**ON-SITE SEWAGE DISPOSAL SYSTEM
HOWARD COUNTY HEALTH DEPARTMENT
BUREAU OF ENVIRONMENTAL HEALTH**

SUBDIVISION: Gaither Hunt LOT NUMBER: 78

ADDRESS: 11009 Hunter's View Road PROPERTY OWNER: _____

Approved Septic System Plan

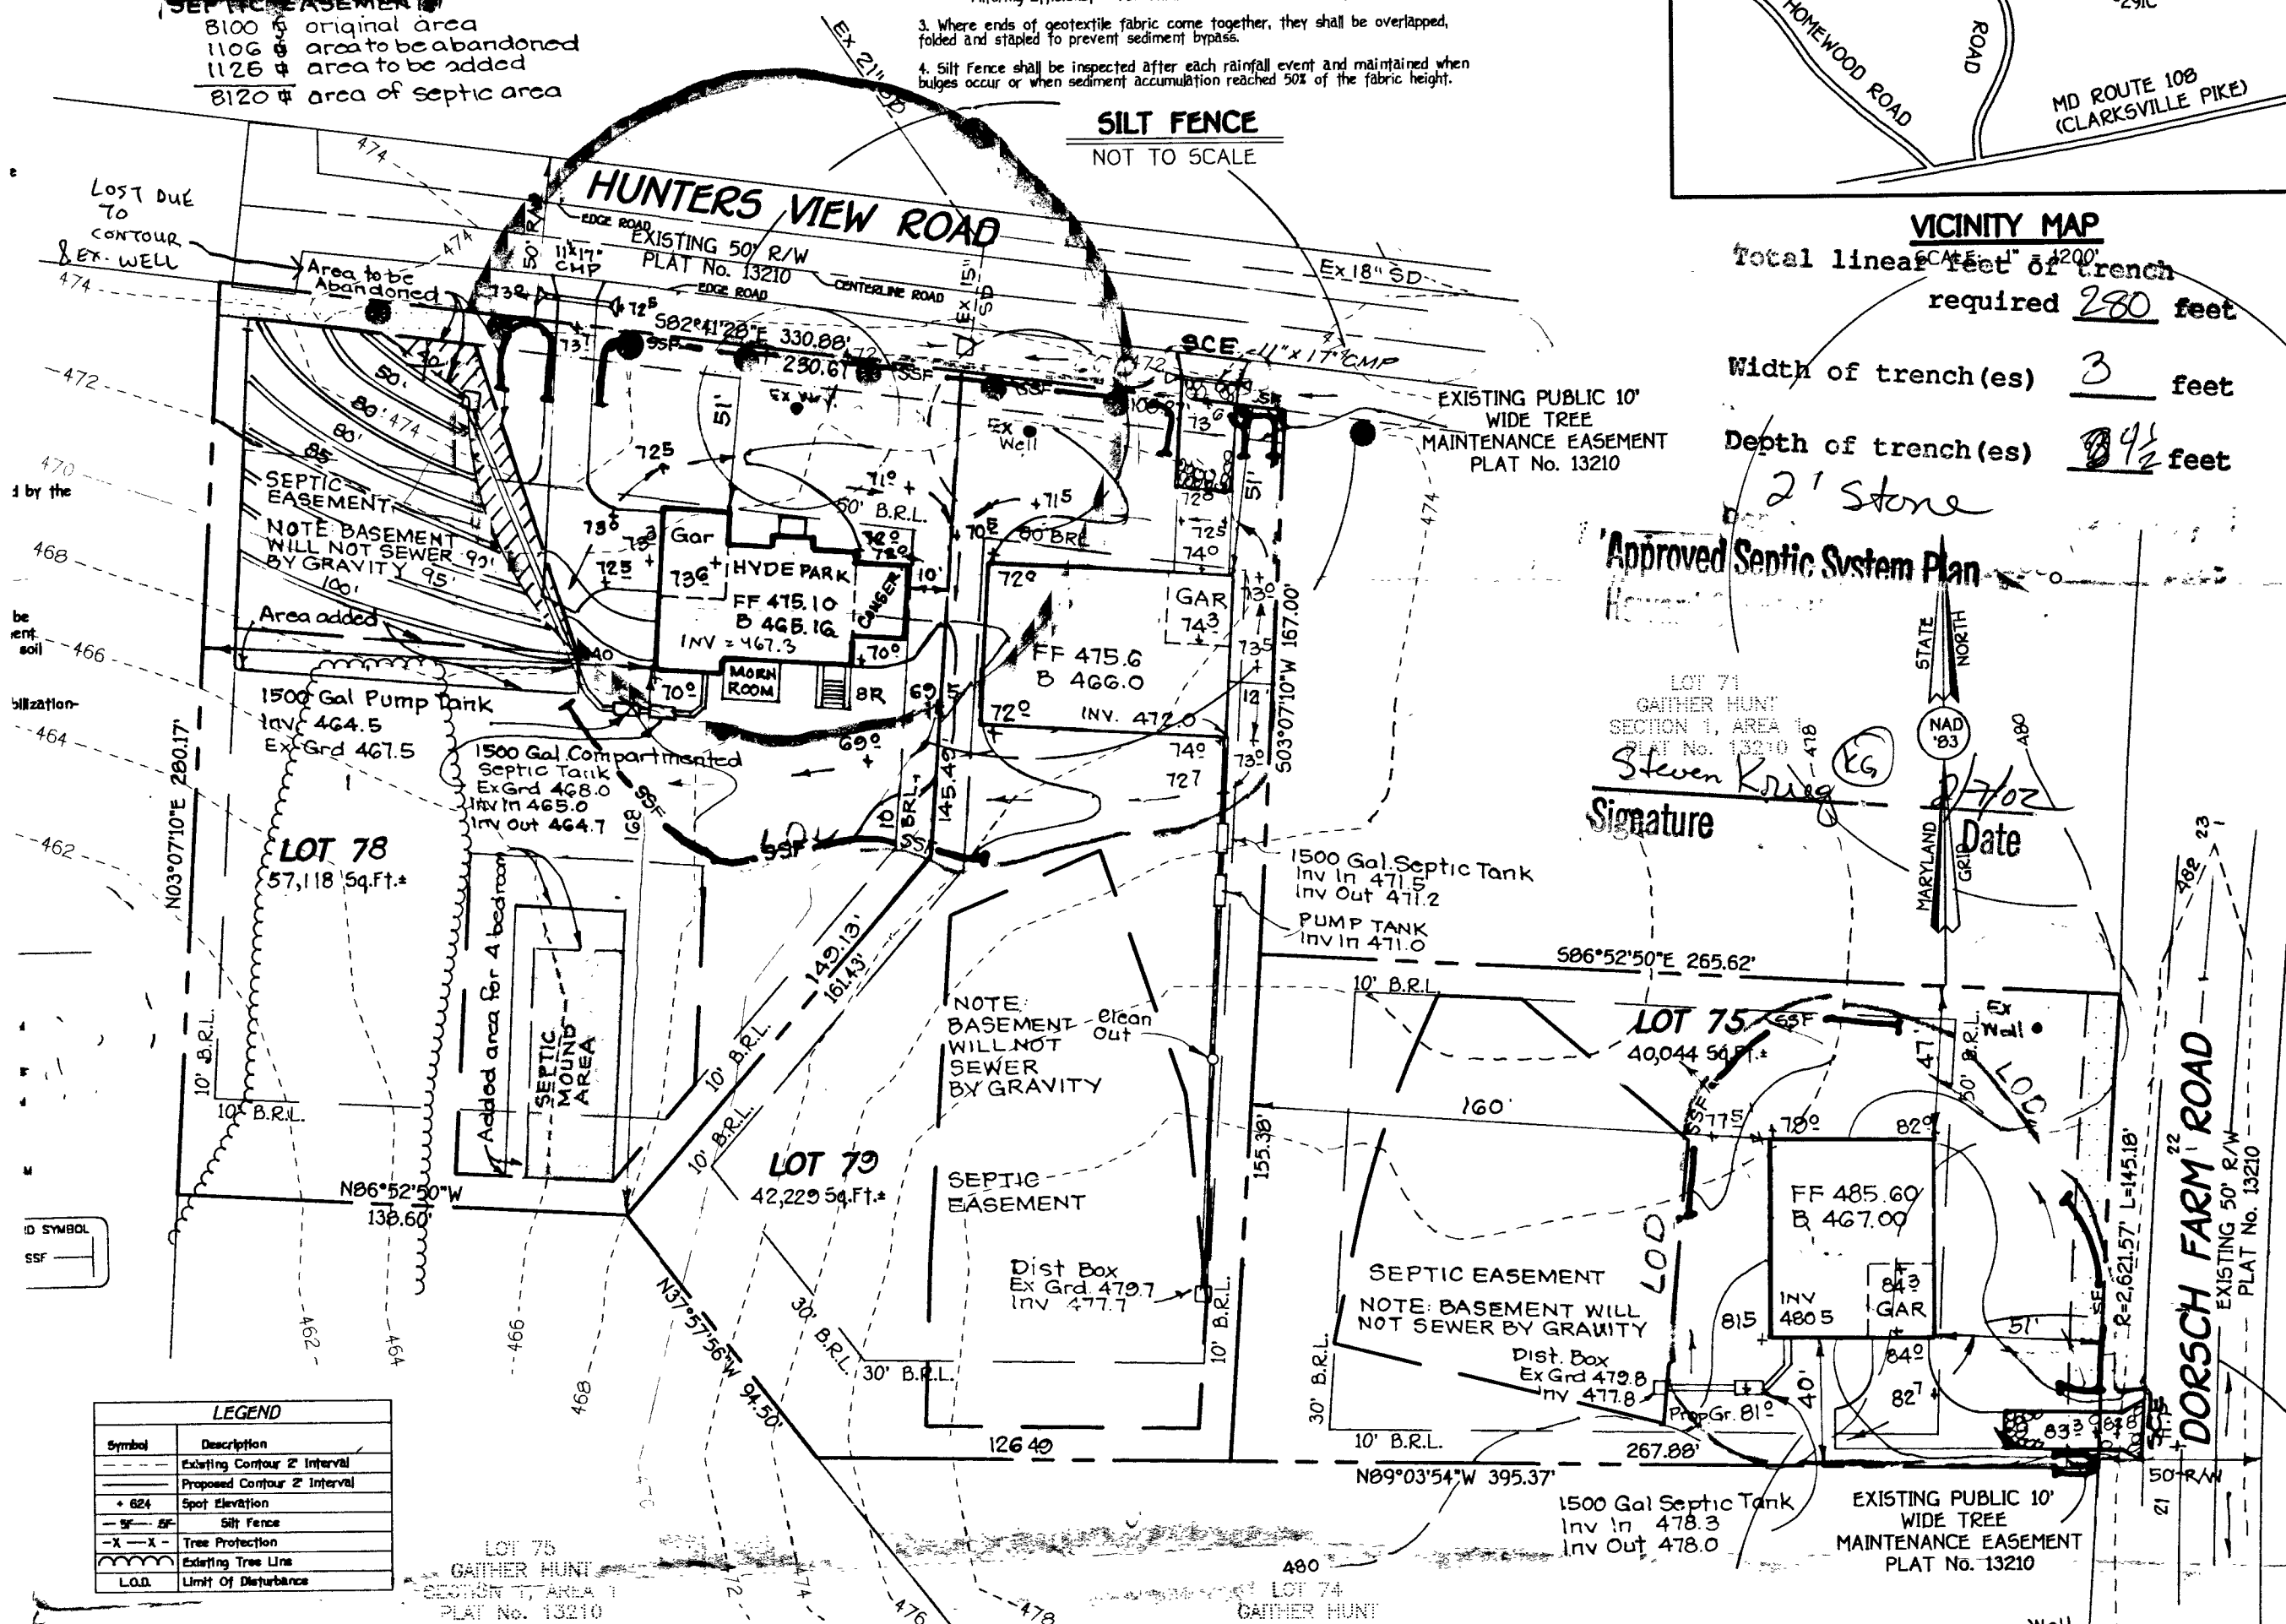
PRE-CONSTRUCTION INSPECTION: 4/11/02 Lot not staked, have lot staked (SO)
4/17/02 10' C.T.C. Tanks being set further off house to allow for a deck. First two
 INSPECTION COMMENTS: trench will be 6" shallow at far ends (SO) 4/19/02 Tanks
set, Well radials cut into corner of SRA (SO) 4/23/02 OK to cover
all work. Pump & Alarm tests needed (SO)
7/23/02 Pump and alarm working. (BB)
